Architectural Review Board Staff Report

Project Type: Site Development Section Plan

Meeting Date: October 23, 2014

Description: **St. Luke's Hospital Northwest Campus 5th ASDSP**: An Amended Site Development Section Plan, Amended Landscape Plan, Lighting Plan, Architectural Elevations and Architect's Statement of Design for a 38.28 acre tract of land zoned "MU" Medical Use District located northwest of the intersection of South Woods Mill Road and Brookings Park Drive.

Figure 2: Sight-Line Study

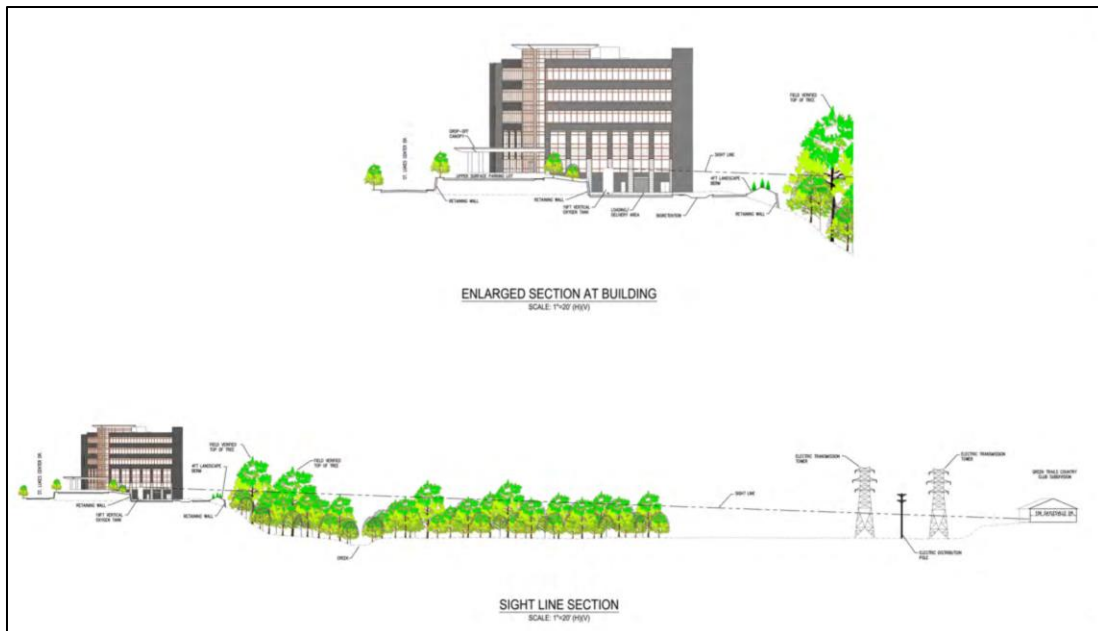
The subject site is between a creek to the west and S. Woods Mill Road and Hwy 141 to the east. The western portion of the site sits on the bluff of the creek. All structures will sit higher on this lot than the adjacent roadways to the east and residential developments to the west. Associated with the proposed development and existing topography of the area is a sight-line study that has been submitted for City analysis due to the site topography versus adjoining properties. While the buildable area of the site is highest at the west side of the property, the

site loses elevation as you move east and north. The proposed building addition is 86 feet in height above adjacent average grade and similar in height to the existing structure on site. A site visit to the western residential properties revealed that the existing medical building is not visible through the thick vegetation. While the existing structure cannot be seen currently, after trees have lost leaves, it may be possible to see these structures. Staff is continuing to evaluate the proposal versus surrounding topography.
